SOKAOGON CHIPPEWA BAND OF MOLE LAKE WISCONSIN DEPARTMENT OF TRANSPORTATION

MOLE LAKE ROAD SAFETY AUDIT

December 2008

FIGURE 5.1 PROPOSED GATEWAY TREATMENT

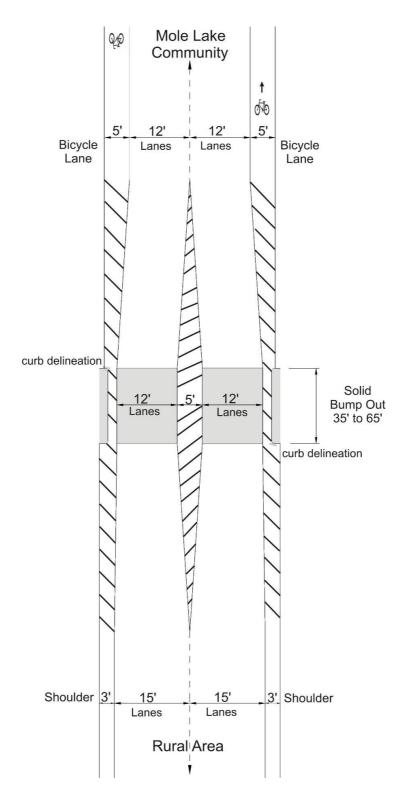
Gateway Treatment

A change in the road environment justifies a reduced speed limit. Drivers tend to travel based on the design speed of the roadway and not the posted speed limit. A gateway treatment may be implemented to inform drivers that they are transitioning from a rural environment into a more urban environment. A gateway treatment consists of measures that promote drivers' awareness that they are entering a more urban area where slower speeds are appropriate. Gateway treatments support, but do not replace, signing for a reduced speed limit.

Research indicated drivers travel at a reduced speed where the height of vertical features is greater than the width of the street⁵. Gateway treatments, which have been summarized from the New Zealand Land Transport Safety Authority, should consist of measures such as:

- Horizontal elements: Raised bump-outs to reinforce that the road is narrowing.
 Raised pavement markers, reflective paint and/or object markers should be used to delineate the raised bump-outs. The center median can either be raised or painted.

- Vertical elements: Oversized speed limit signs, roadside displays identifying entry
 to the Mole Lake community, trees and shrubs including decorative landscaping,
 artistic displays, or architectural displays should be placed adjacent to the bump
 outs. Trees or shrubs should not limit sight distance between oncoming vehicles
 and nearby access points.

- Other elements: Street lighting is desirable where raised bump outs are implemented. Daytime conspicuity can be improved by including bright flowers or shrubs in the landscaping, or colored or textured pavement within the gateway. Night-time conspicuity can be improved by using highly reflective pavement markings and lighting.

FIGURE 5.1 illustrates the gateway treatment concept.

Safety Issue 6(a): 10 ft lanes

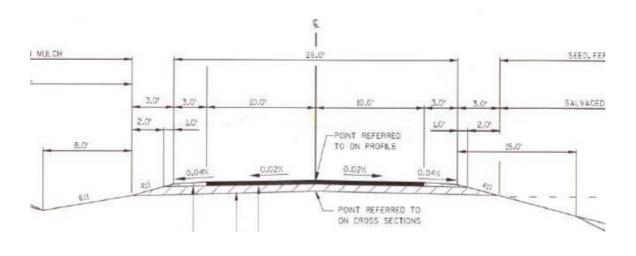
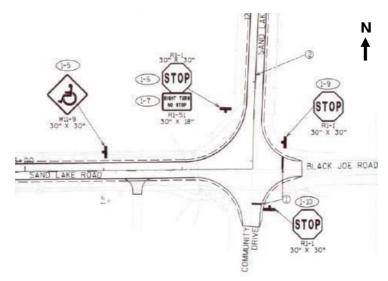
Safety Issue 6(a) Description:

Sand Lake Road is a primary connection between STH 55 and CTH W. It is also the main access point for the tribal offices and the future ATV campground. During site visits a high volume of logging trucks and dump trucks were observed utilizing the roadway. The existing pavement condition is also deteriorating, affecting driver control and load stability.

Expected Frequency: Occasional

Expected Severity: Low

Risk Rating: B (low crash risk)

Twelve foot lanes are recommended on Sand Lake Road to accommodate the future traffic growth of large vehicles. The Geometric Design of Highway and Streets⁹ states that 12 foot wide lanes provide desirable clearance between large vehicles on two-lane two-way rural highways where large vehicles are expected. It is recommended that the tribe confirm that the lane widths in the designs have been updated to 12 foot lanes.
